The Water House

Comments on information provided by the Applicants in February 2016

drg. no.
1675/113/SK10

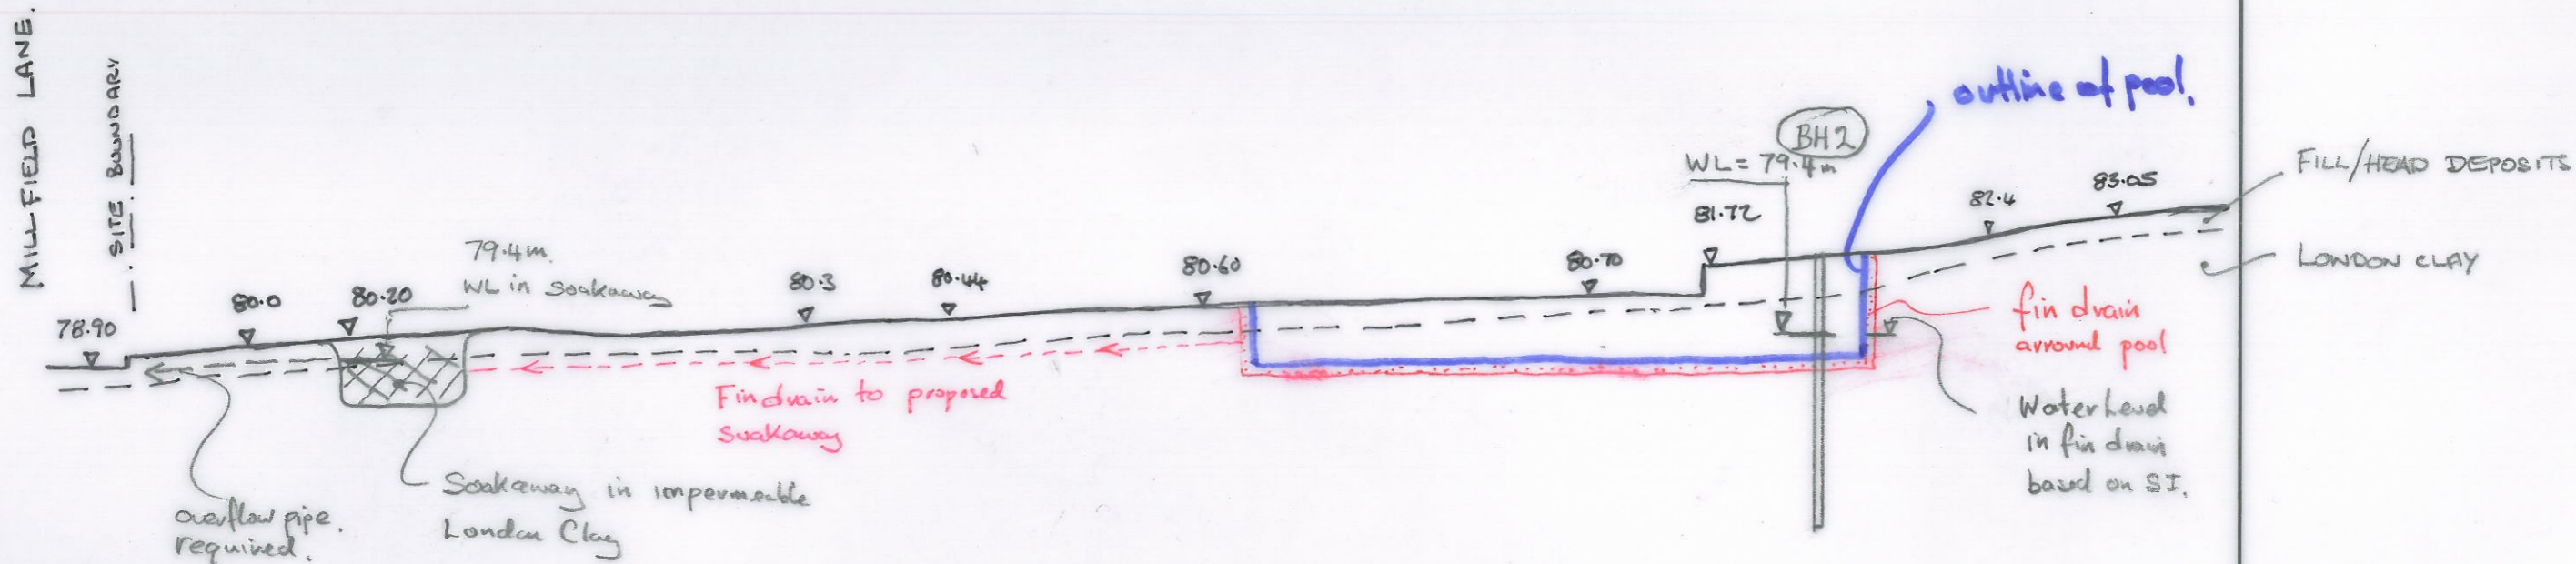
The recorded level of the groundwater in borehole no. 2 was 79.4m OD which is approximately the same as the ground level at the location of the soakaway and at least 1m higher than the level of Millfield Lane. Therefore, unless a proper drain route is provided, there is a high risk of groundwater flowing across Millfield Lane. See Section A-A on drawing No. 1675/113/SK10 attached.

Water level in soakaway is above the level of Millfield Lane ∴ overflow drain required or excess ground water will flow over the Lane to the Heath.
